# DISTRIBUTION CODE MODIFICATION PROPOSAL FORM

<b>Modification Proposal submitted By:</b>	<b>DATE OF SUBMISSION OF PROPOSAL:</b>	<b>Modification Proposal Number:</b> <i>(to be assigned by Review Panel Secretary)</i>
Tony Hearne	9th April 2013	#23
<b>CONTACT DETAILS FOR MODIFICATION PROPOSAL ORIGINATOR: (IF NOT DISTRIBUTION CODE REVIEW PANEL)</b>		
<b>NAME:</b>		<b>TELEPHONE NUMBER:</b>
Tony Hearne		01 7026276
<b>E-MAIL ADDRESS:</b>	tony.hearne@esb.ie	
<b>MODIFICATION PROPOSAL TITLE:</b>	DS3 Reactive Power and voltage control	
<b>DISTRIBUTION CODE SECTION(S) AFFECTED BY PROPOSAL</b>		
<ol style="list-style-type: none"> <li>1. Table 5</li> <li>2. DCC11.4</li> <li>3. DCC11..5</li> </ol>		
<b>MODIFICATION PROPOSAL DESCRIPTION</b> <i>(Clearly state the desired amendment and all text changes. Attach further information if necessary)</i>		
<ol style="list-style-type: none"> <li>1. Update Table 5: Change from "Voltage Regulation" to Voltage Control". Update references to DCC11.4 AND DCC11.5.2.6, as depicted in Appendix 1</li> <li>2. Replace the current content of DCC11.4 with the material shown in Appendix 2</li> <li>3. Create new Section DCC11.5.2.6 with the material shown in Appendix 3<

Figure 12a

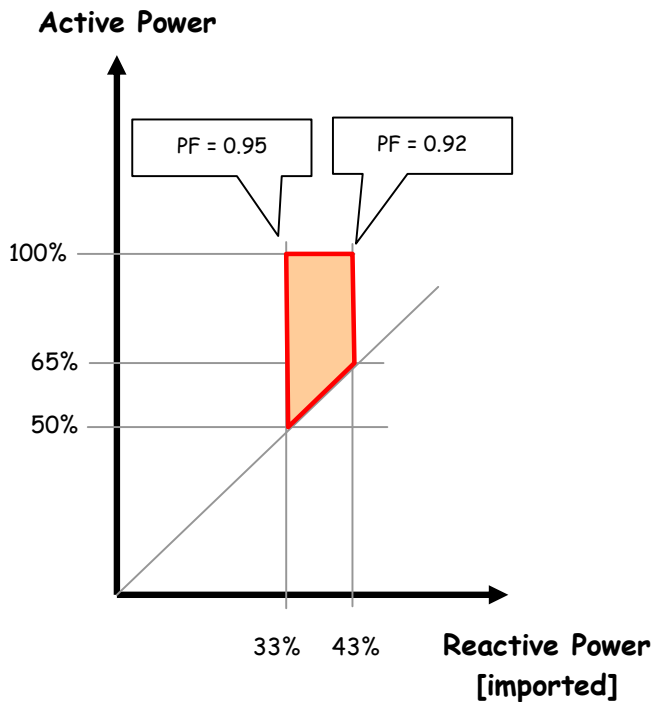
Wind Farm Power Stations, with connection types B with a Registered Capacity of <5MW and connection types C, D or E, shall keep power factor between 0.92 and 0.95, as measured at the connection point, such that VARs are absorbed by the Wind Farm Power Stations from the Distribution System. This power factor range is illustrated in Figure 12a.

Figure 13 - Reactive Power Capability of Wind Farm Power Station

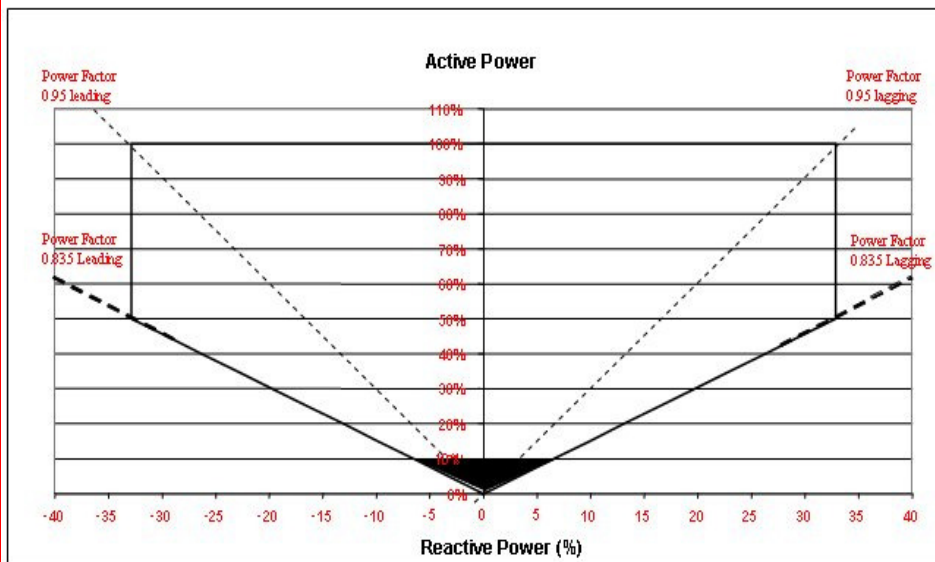
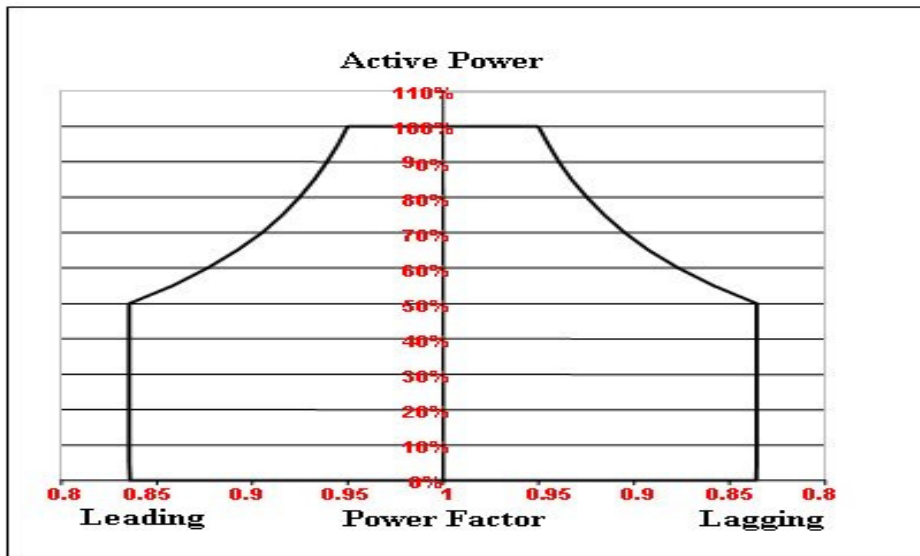
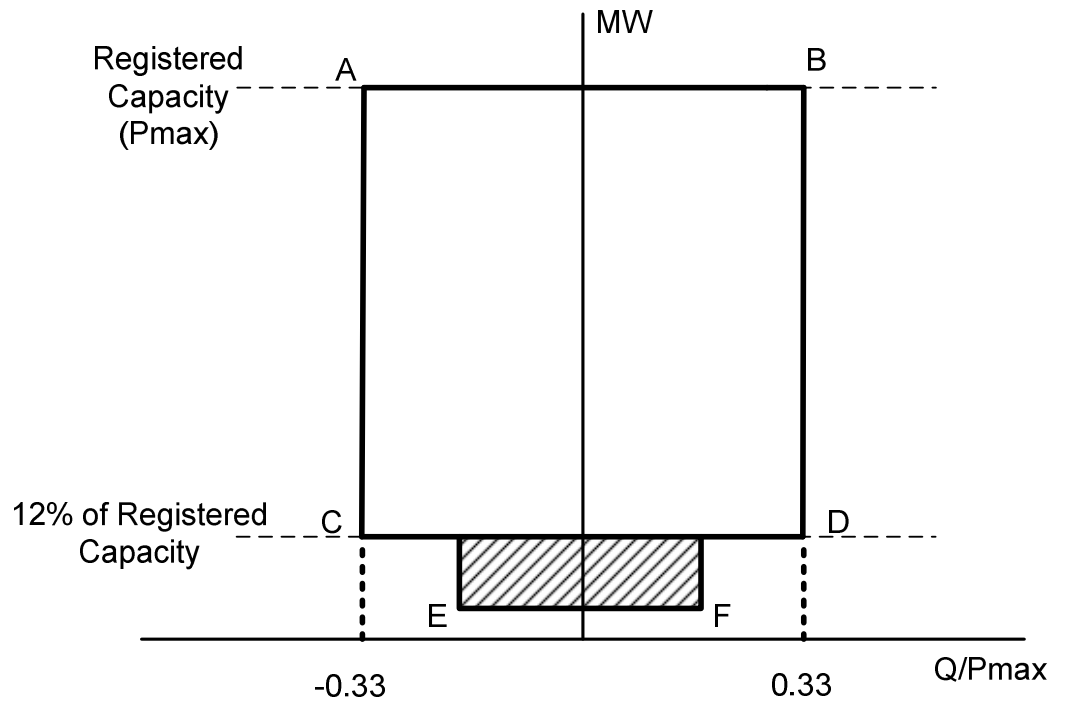
DCC11.4.5.2 Wind Farm Power Stations, Type B with Registered Capacity  $\geq 5\text{MW}$ , shall be capable of operating at any point within the Power Factor ranges illustrated in Figure 13. The capability must be implemented at the Connection Point

DSO Type A Controllable WFPSs and DSO Type B Controllable WFPSs with Registered Capacity  $\geq 5\text{MW}$ , operating in **Power Factor** control mode, Voltage Control Mode or Constant Reactive Power mode shall be at least capable of operating at any point within the P-Q capability ranges illustrated in *Figure 13*, as measured at the **Connection Point** and shall be capable of providing this capability over the full range of voltages specified in Table 5A.

Point A represents the minimum Mvar absorption capability of the **Controllable WFPS** at 100% **Registered Capacity** and is equivalent to 0.95 power factor with the **WFPS** importing VARs;

Point B represents the minimum Mvar production capability of the **Controllable WFPS** at 100% **Registered Capacity** and is equivalent to 0.95 power factor with the **WFPS** exporting VARs;

Point C represents the minimum Mvar absorption capability of the **Controllable WFPS** at 12% **Registered Capacity** and is equivalent to the same **Mvar** as Point A;

Point D represents the minimum Mvar production capability of the **Controllable WFPS** at 12% **Registered Capacity** and is equivalent to the same **Mvar** as Point B;

Point E represents the minimum Mvar absorption capability of the **Controllable WFPS** at the cut-in speed of the individual **WTGs**;

Point F represents the minimum Mvar production capability of the **Controllable WFPS** at the cut-in speed of the individual **WTGs**;

It is accepted that the values of Points E and F may vary depending on the number of **WTGs** generating electricity in a low-wind scenario;

Figure 13 represents the minimum expected reactive power capabilities of the **Controllable WFPS**. The **Controllable WFPS** is obliged to tell ESB Networks if it can exceed these capabilities, and submit the actual P-Q capability diagram based upon the installed plant and **Collector Network** characteristics to the **DSO** during **Commissioning**.
